UNITED STATES PATENT AND TRADEMARK OFFICE

Office Action Summary	Application No. 10/529,239	Applicant(s) CHOI ET AL.	
	Examiner David C. Reese	Art Unit 3677

DETAILED ACTION

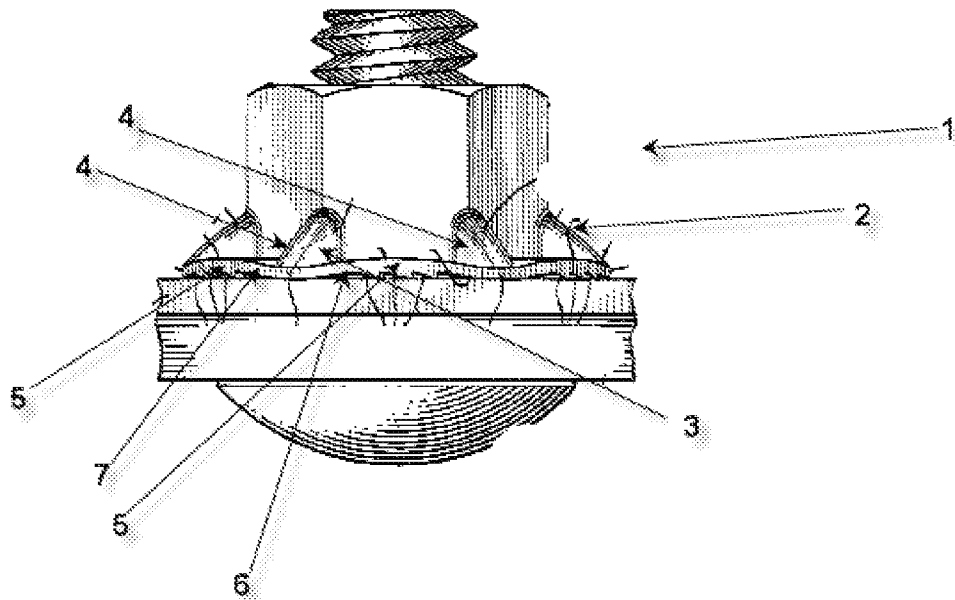
As for Claim 1, Grube discloses of a lock nut (1) (see figure below) [for a leg assembly of electric home appliances], comprising:

a plurality of ribs (2) extending in a radius direction from a circumference of a hub, each rib having first (3) and second sides (4) over which [a tool or finger for rotating the hub about the leg bolt]; and

a plurality of supplementary members (5), each supplementary member (5) [being configured to provide the tool or finger access from the radius direction of the hub to the first (3) or second side (4)], and coupling the ribs (2);

wherein an inclination direction of a first supplementary member (5) adjacent to the first side (3) and an inclination direction of a second supplementary member (5) adjacent to the second side (4) are upward (at 6) and downward (at 7) alternatively.

The above statement in brackets is an example of intended use, with the prior art only needing to be capable of performing said function to be anticipatory towards that of the prior art, and in the instant case, the lock nut as presented by Grube is indeed capable of being used for a leg assembly of electric home appliances, as well as having a tool or finger access said nut (at the

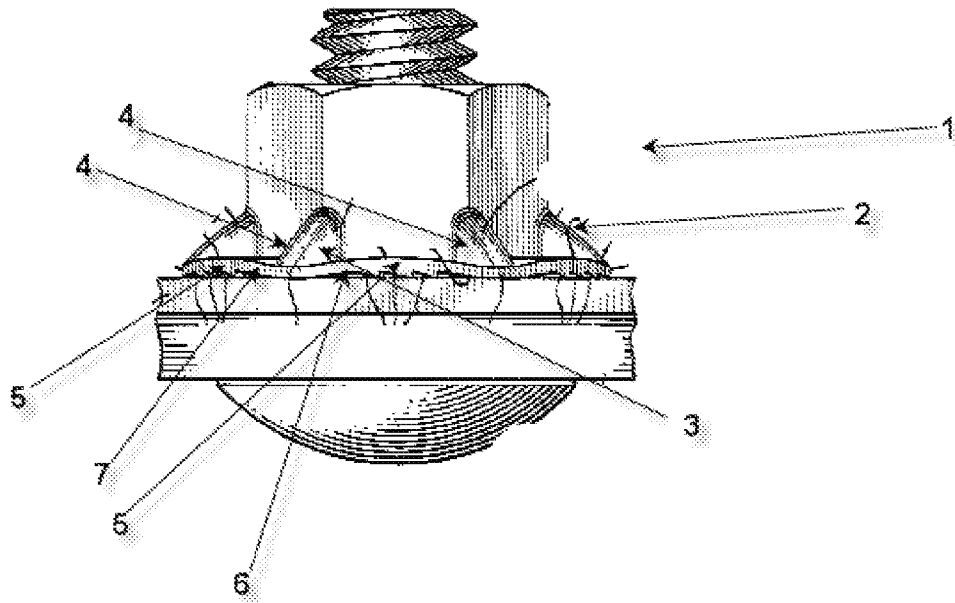
As for Claim 22, Grube teaches of a lock nut (1) for a leg assembly (see figure below), comprising:

a hub having a screw hole through which a leg bolt passes, the leg bolt coupled with an electric home appliance;

a plurality of ribs (2) extended in a radius direction from a circumference of the hub, each having first (3) and second sides (4) over which [a tool or finger accessed from the radius direction of the hub is hooked so as to rotate the hub about the leg bolt];

a plurality of extension members (5), each extension member (5) being extended from a circumference of the hub to a space between the ribs (2); and

a rim (outer portion of 5) for coupling end portion of the ribs(2),

wherein an inclination direction (6) of a first extension member (5) adjacent to the first side (3) is different than an inclination direction (7) of a second extension member (5) adjacent to the second side.

The difference between the claim and Grube is that Grube does not expressly state that the locking nut is used in conjunction with a leg bolt coupled with an electric home appliance. First, it is extremely obvious and apparent to one skilled in the art of fasteners of the diverse functionality of locking nuts. The use of locking nuts for a variety of applications including that of with home appliances is widely held and understood to those in the art. To show the use of a nut in conjunction with a leg bolt coupled with an electric home appliance the examiner submits the reference of Johnson. Johnson discloses a threaded locking nut attached to a leg bolt of a home appliance, specifically a washing machine. Thus, it would have obvious to one skilled in
